February 15, 2010  
NRC3-10-0005

Subject: Detroit Edison Company Response to NRC Requests for Additional Information Letter No. 2 Related to the Environmental Review

**Appendix A**  
**NRC3-10-0005**

**List of RAI Responses in this Letter**

**Eastern Fox Snake Sightings Map  
(following 1 page)**

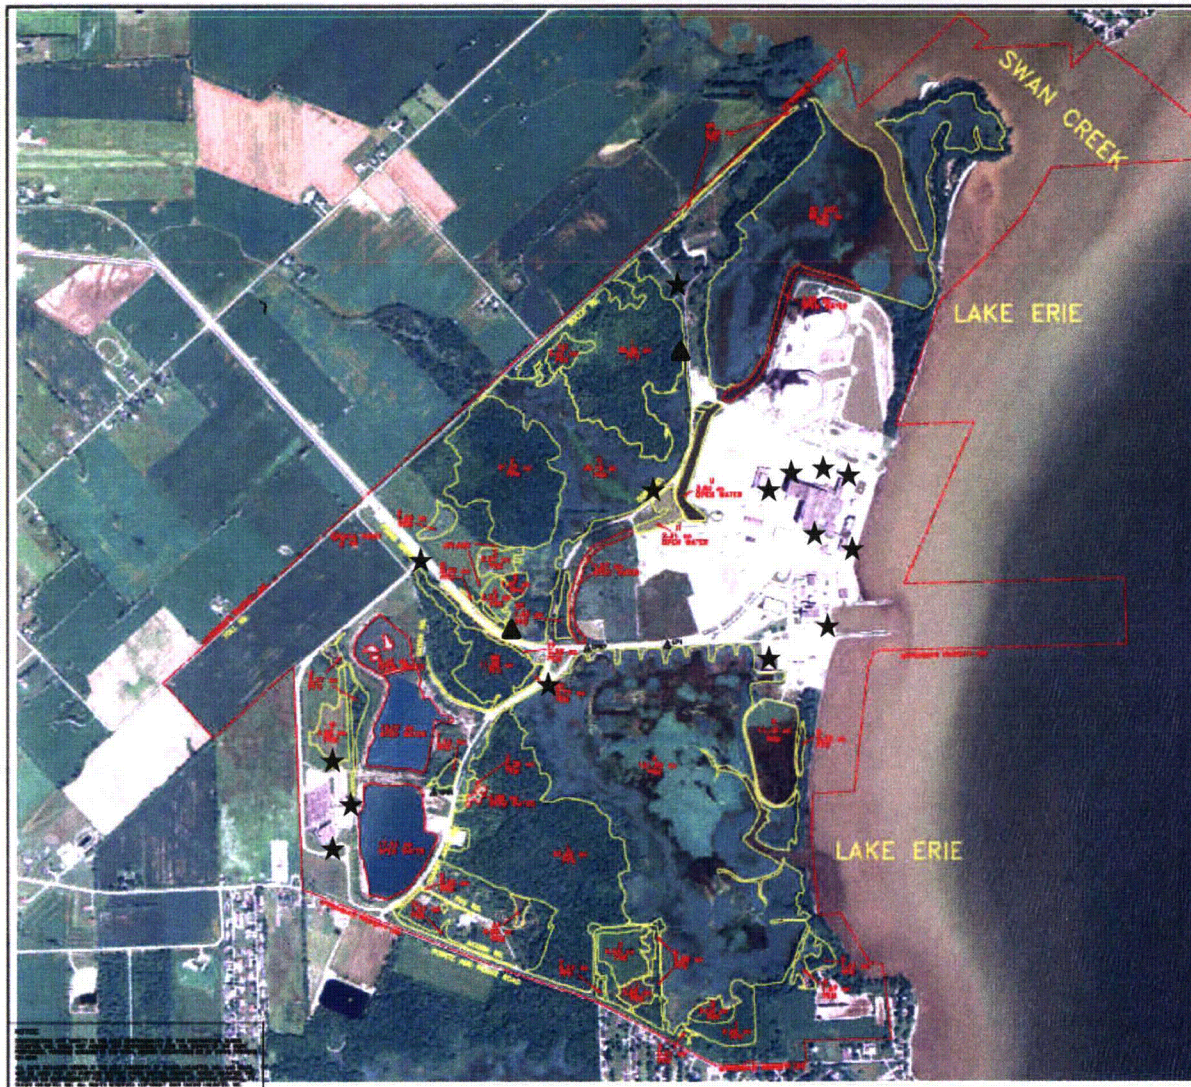
*Provide up-to-date and complete data on the locations and dates of sightings of the eastern fox snake (*Pantherophis gloydi*) on the proposed Fermi 3 site, including any sightings by Detroit Edison staff or others in the last 10 years.*

A map indicating where known observations of eastern fox snakes have occurred is provided as Enclosure 1 to this response. The sightings which are indicated as having been made by Detroit Edison employees (represented by stars on the map) were made from 1990 to 2007. Two sightings made by Ducks Unlimited (represented by triangles on the map) were made during a site wetland survey conducted in 2008.
